AMERICAN EAGLE

STOREFRONT ELEVATIONS

AMERICAN EAGLE OUTFITTERS
Forum Tec C.C.
Tepic, Nayarit

A.1.300

E ELEVATION
A.1.601 SCALE: 1/4" = 1'-0" (1:50)

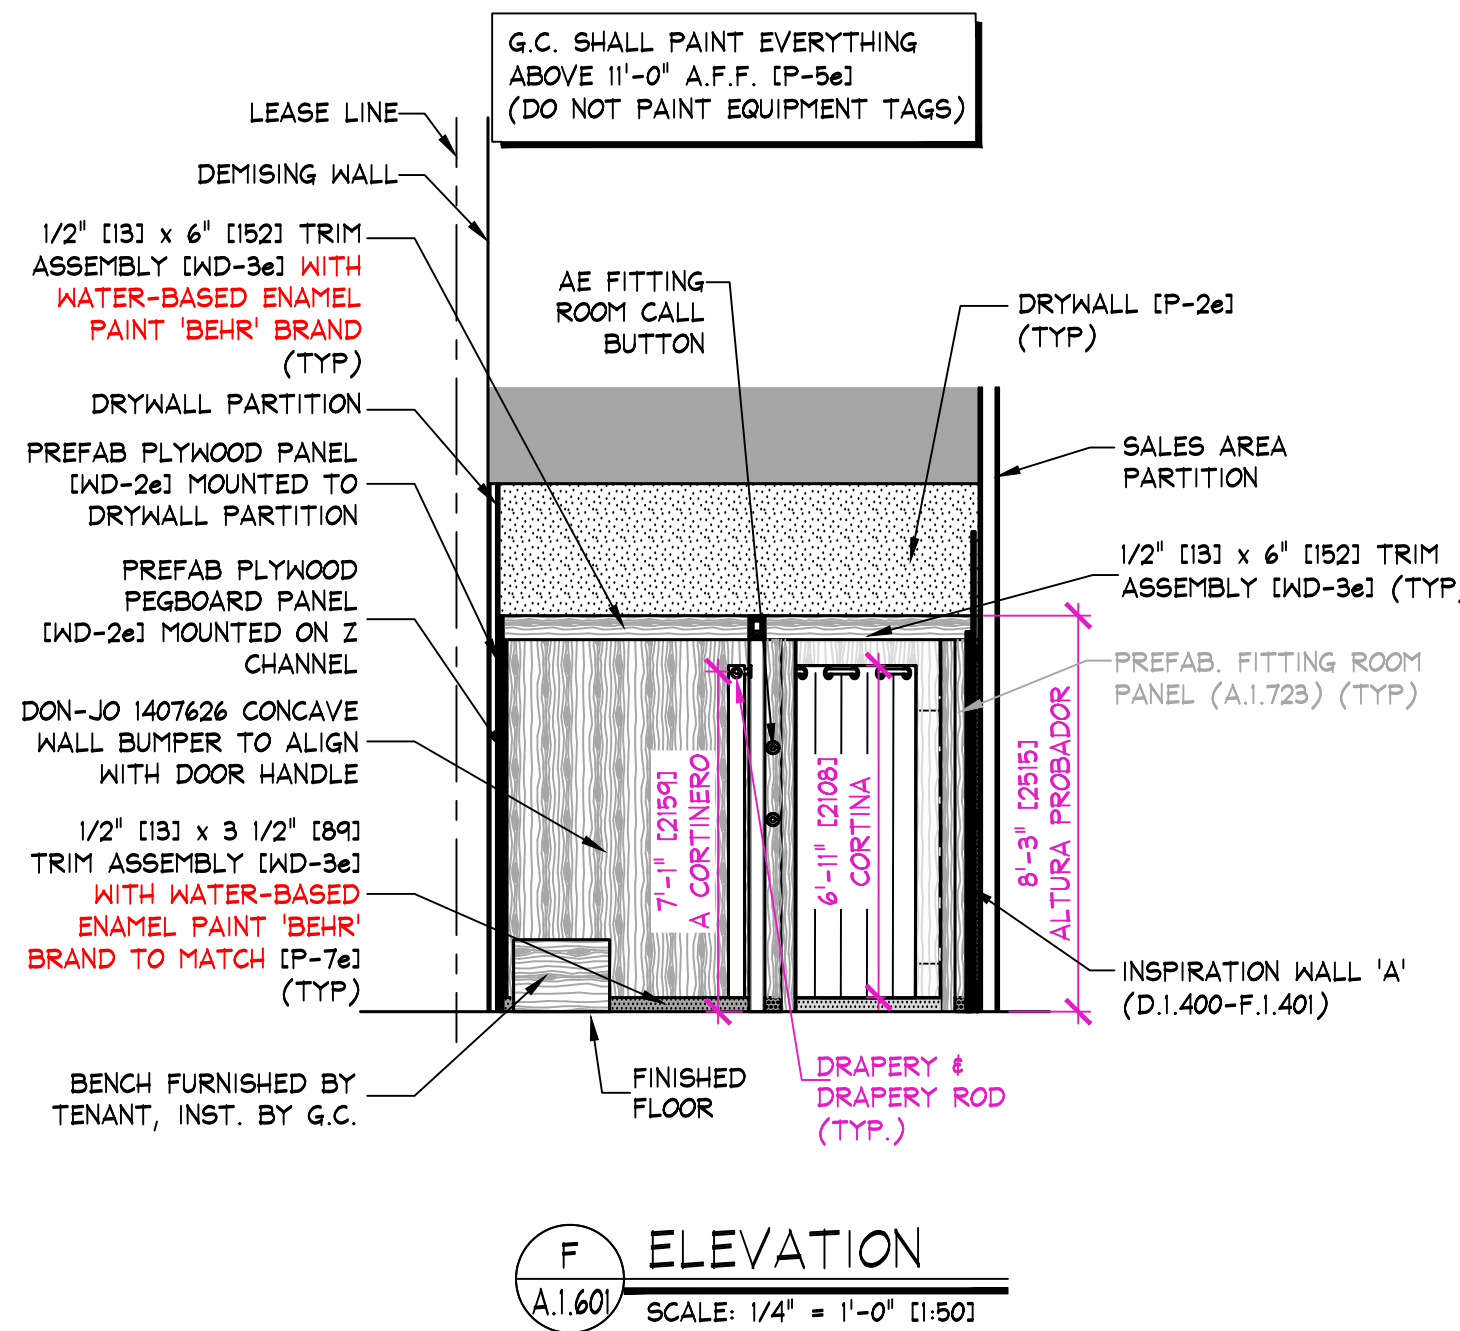
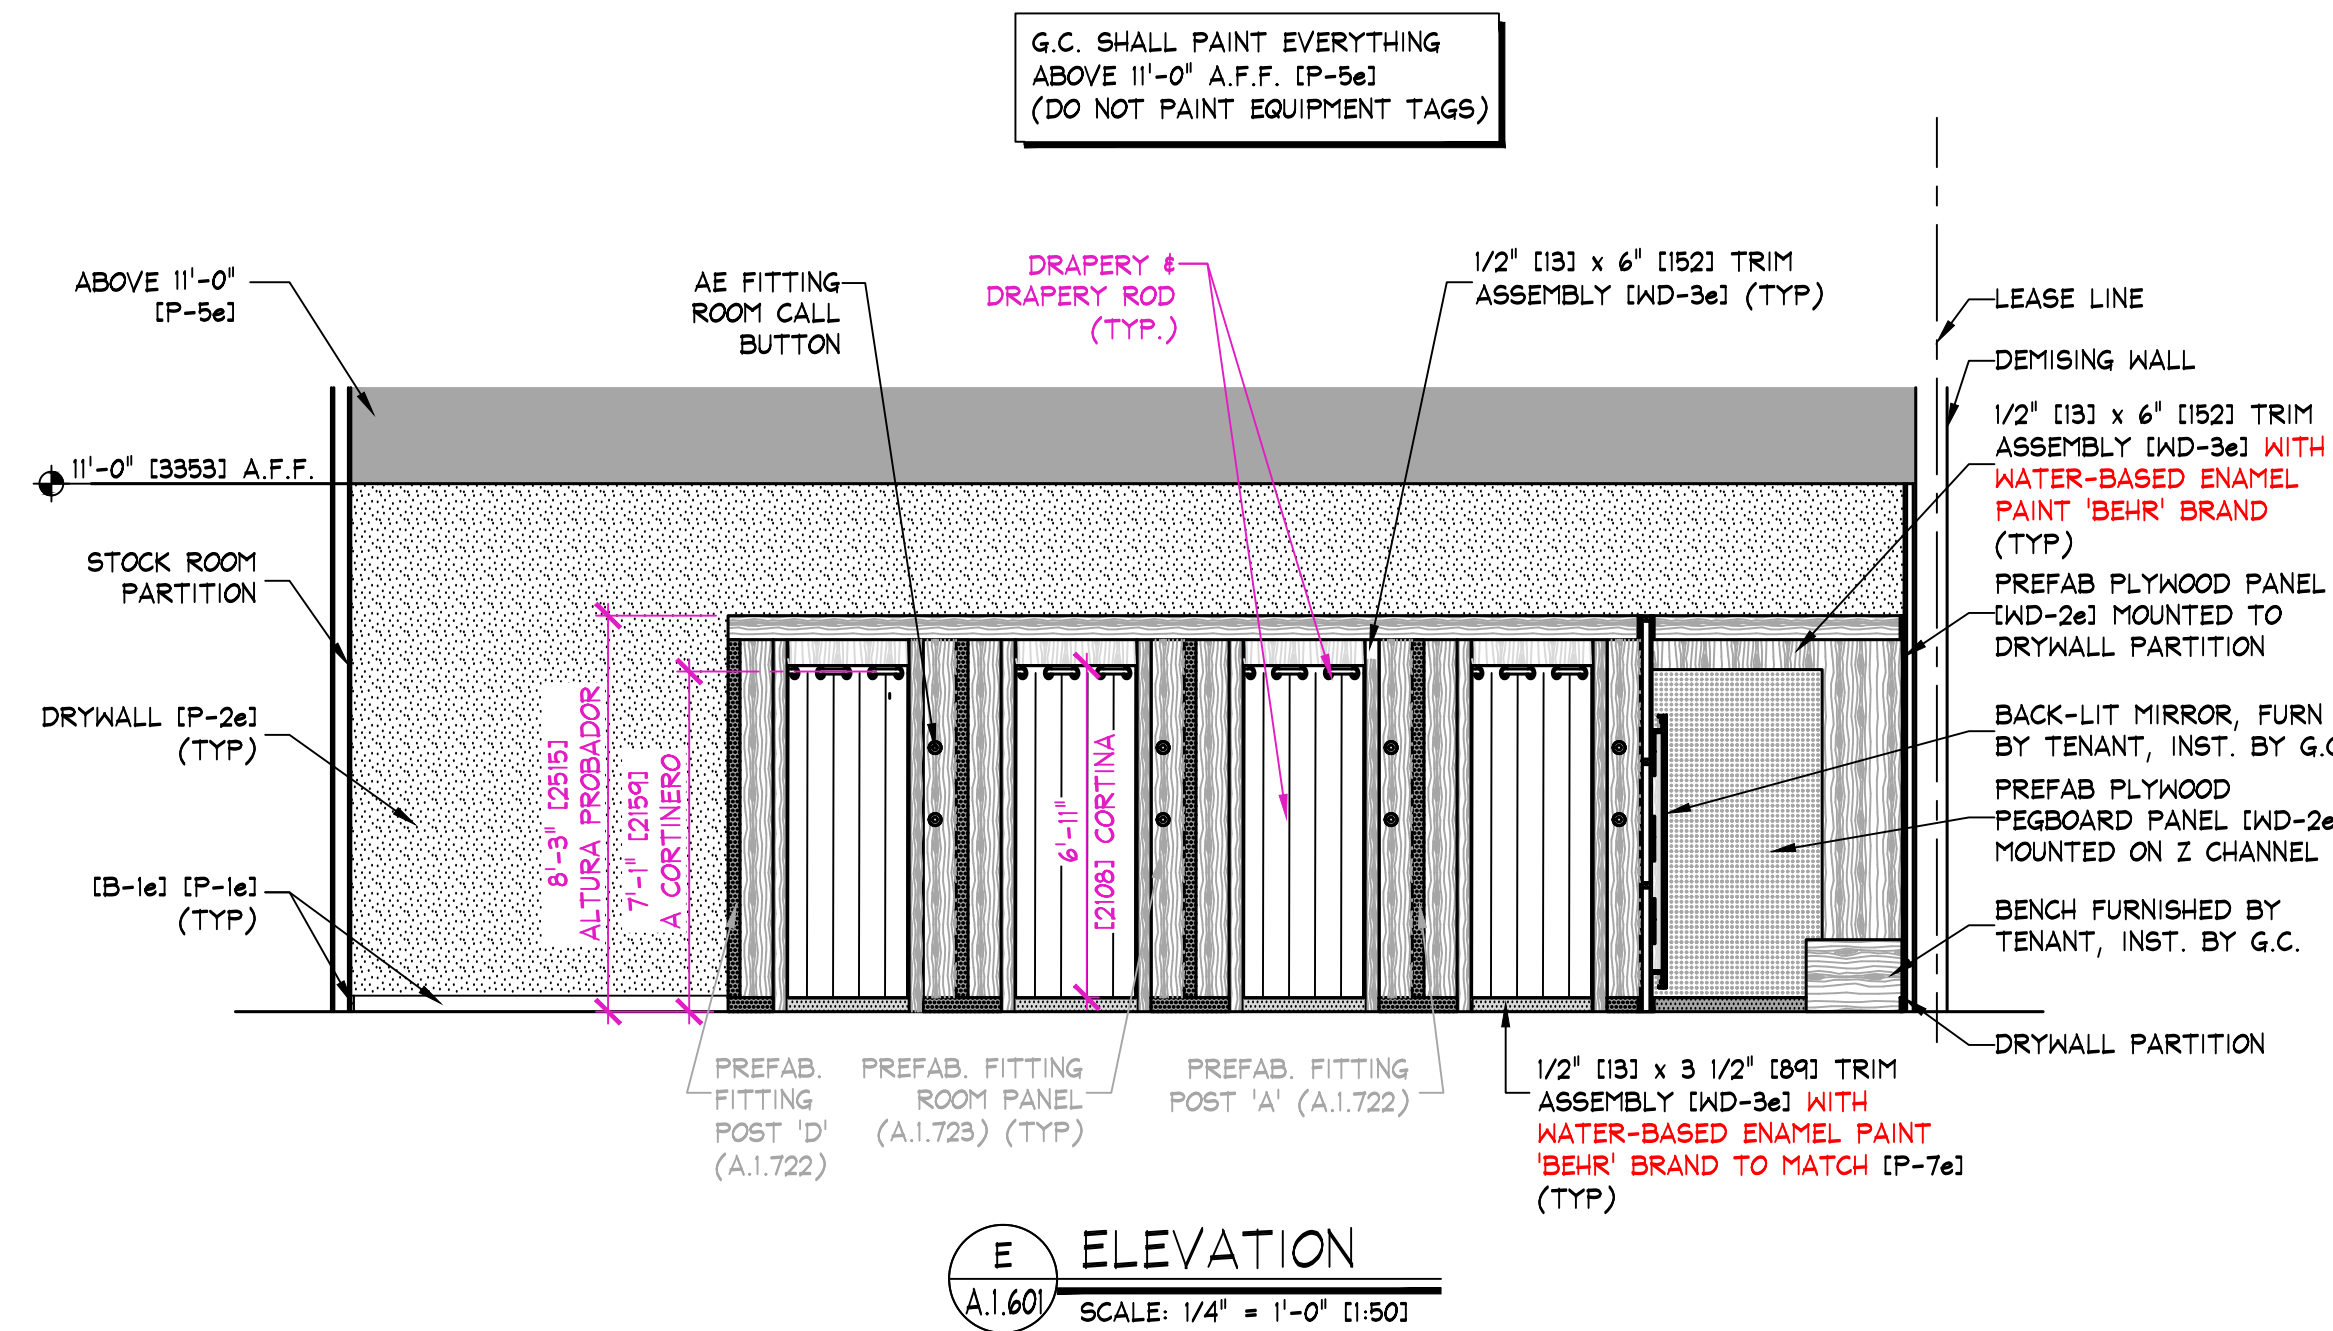
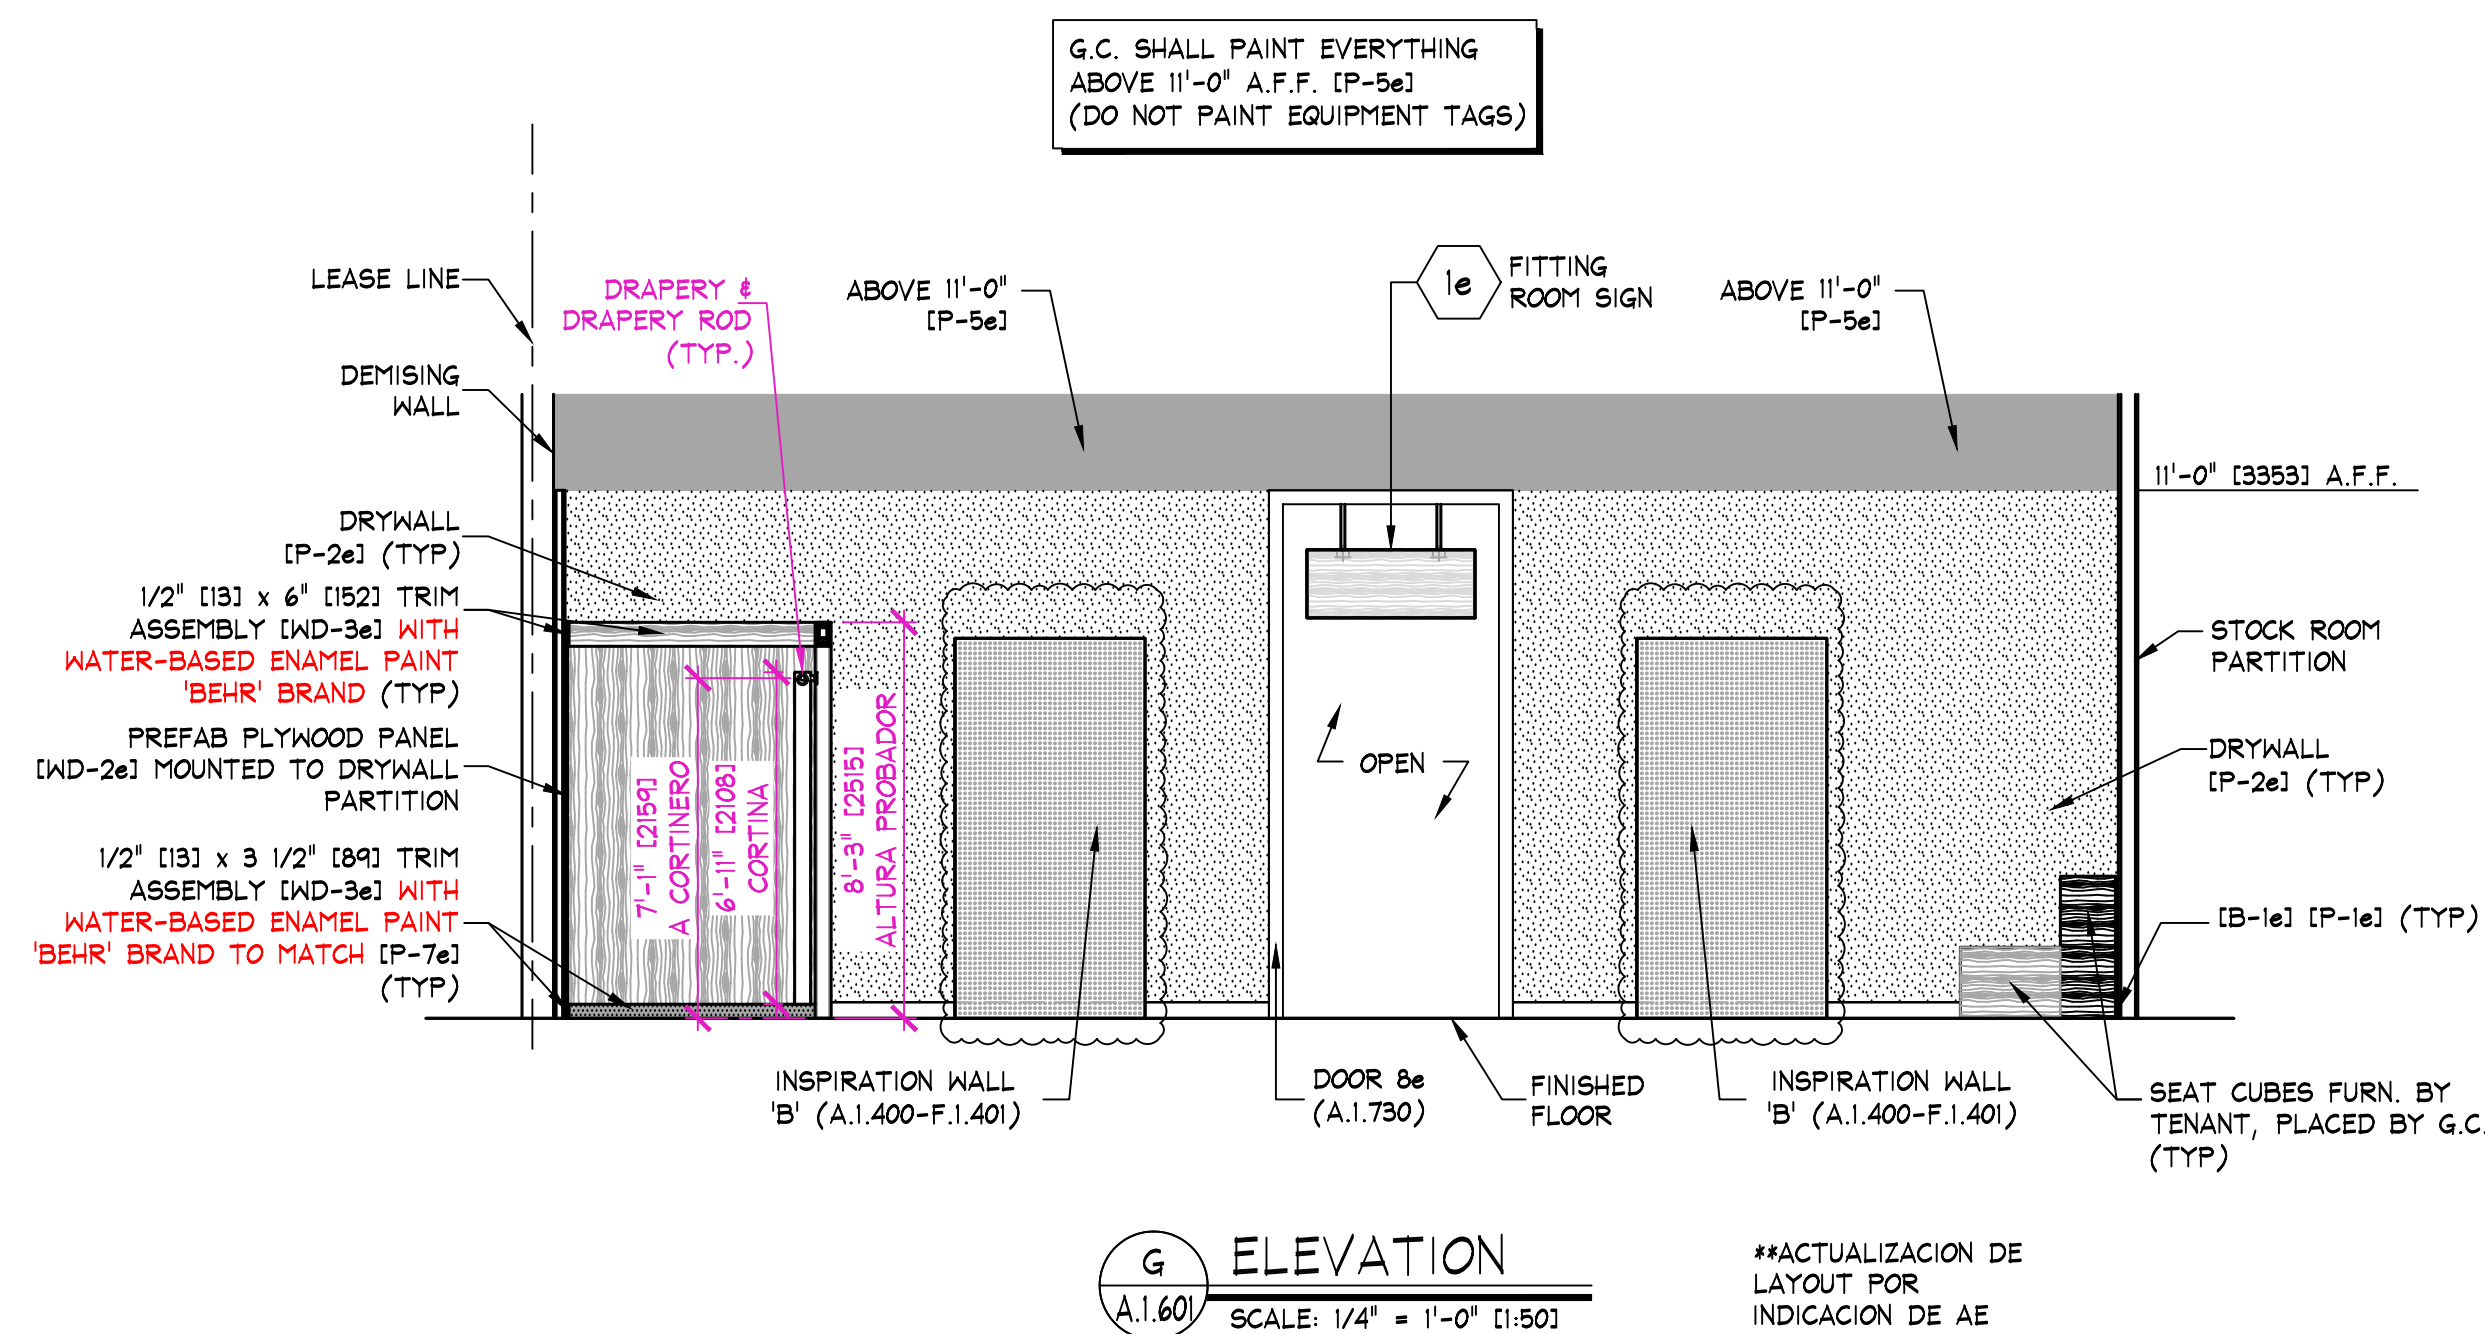
**ACTUALIZACION DE LAYOUT POR INDICACION DE AE (16-AGOSTO-2022)

**ACTUALIZACION DE LAYOUT POR INDICACION DE AE (29-JULIO-2022)
EN PROBADORES: SE REUBICA PARTE DEL MOBILIARIO Y SE RECORRE EL ACCESO, DE MANERA QUE QUEDA EN LA PARTE TRASERA DE LA COLUMNA.
**ACTUALIZACION DE LAYOUT POR INDICACION DE AE (23-SEPTIEMBRE-2022):
LOS PROBADORES PARA ESTE PROYECTO SERAN REALIZADOS EN SITIO.
SE QUITA PUERTA DE PROBADORES Y SE COLOCA CORTINERO, POR INDICACIONES AE
